RE: Docket No.: 20240032-SU; Application for original wastewater certificate by Environmental Utilities, LLC in Charlotte County

On behalf of Environmental Utilities, LLC ("Utility") this letter is the response to Staff's Deficiency Letter dated March 13, 2024.

EVALUATION OF WASTEWATER COLLECTION TECHNOLOGIES

BOCILLA AREA CONCEPTUAL PIPE NETWORK

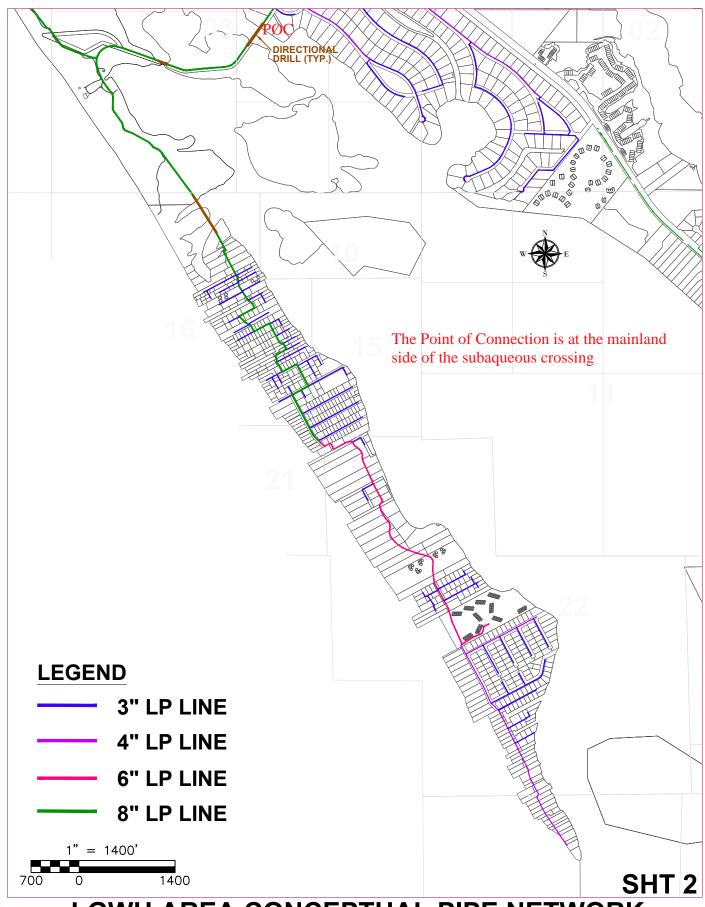
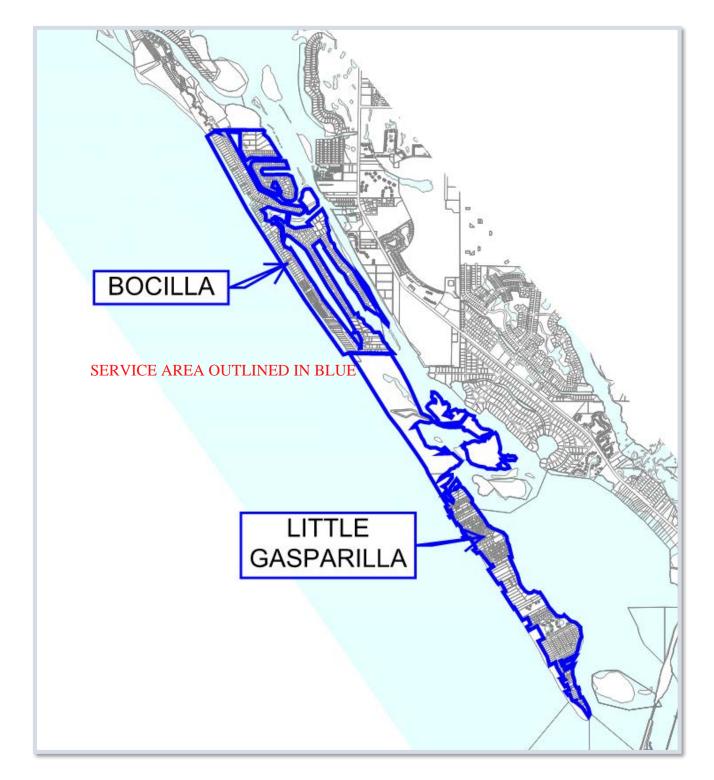
6. **System Map.** Rule 25-30.033(1)(j)2., F.A.C., requires that the applicant provide a detailed system map showing the existing and proposed lines and treatment facilities, with the territory proposed to be served plotted thereon. The system map does not clearly show the point of interconnection with the Charlotte County Utilities Department. Please provide a revised system map corrected to designate the point of interconnection.

Response: The attached system map has been revised to reflect the point of connection where the Utility's responsibilities end.
